Sheet:  
File: board.kicad\_pcb

Title: NanoE-DMX

Rev: 1.0

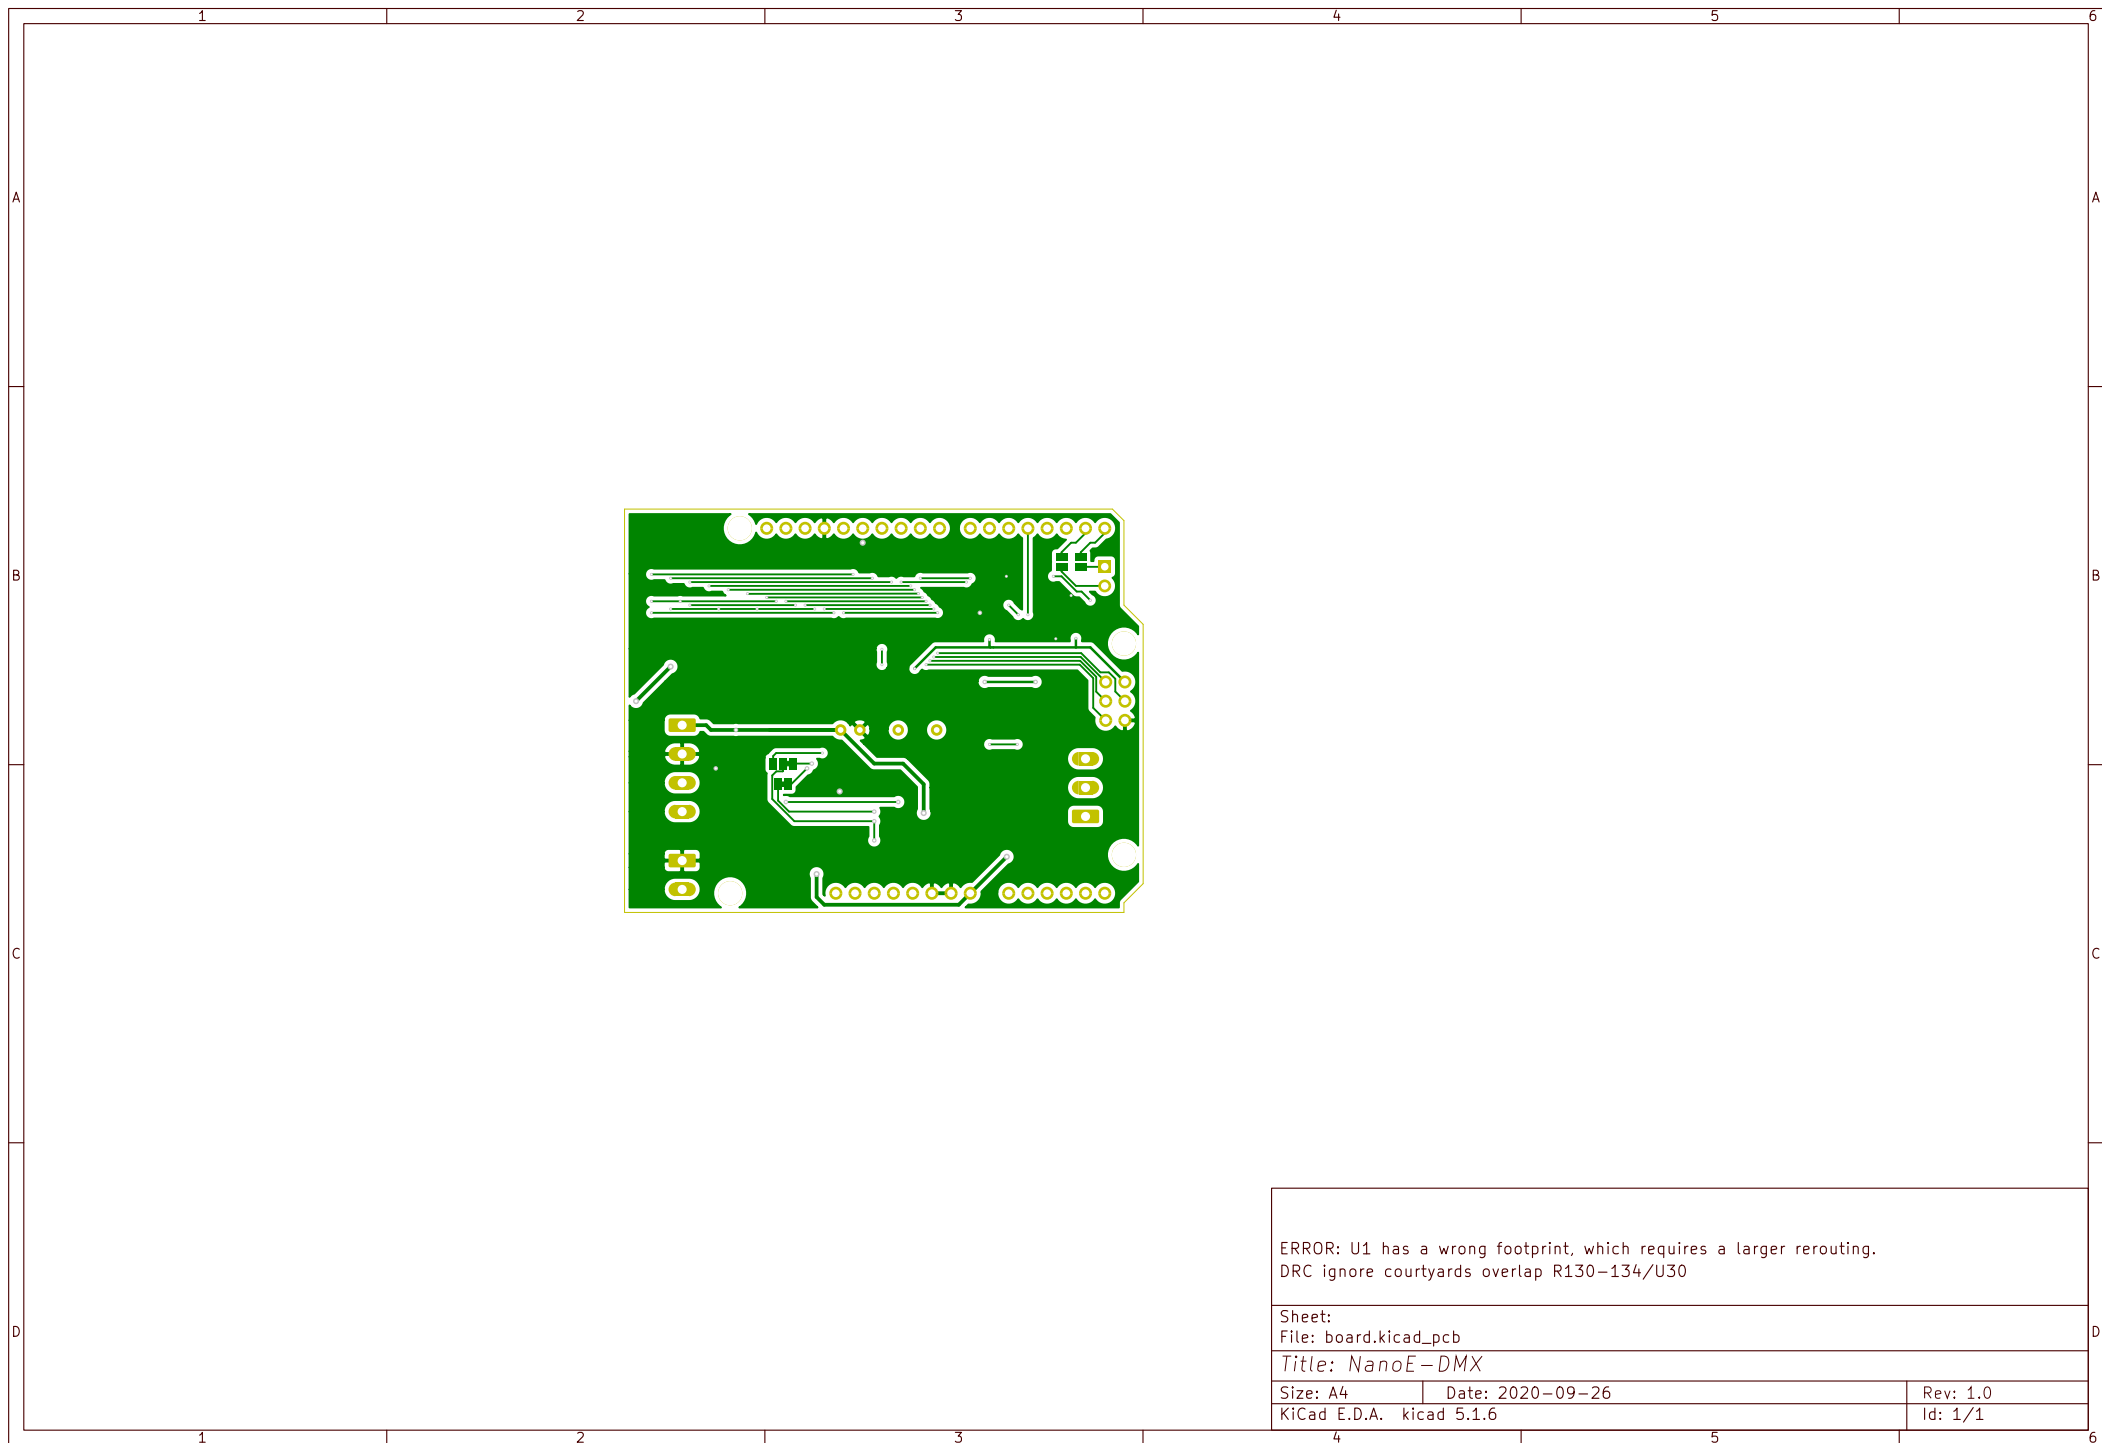
ERROR: U1 has a wrong footprint, which requires a larger rerouting.  
DRC ignore courtyards overlap R130-134/U30
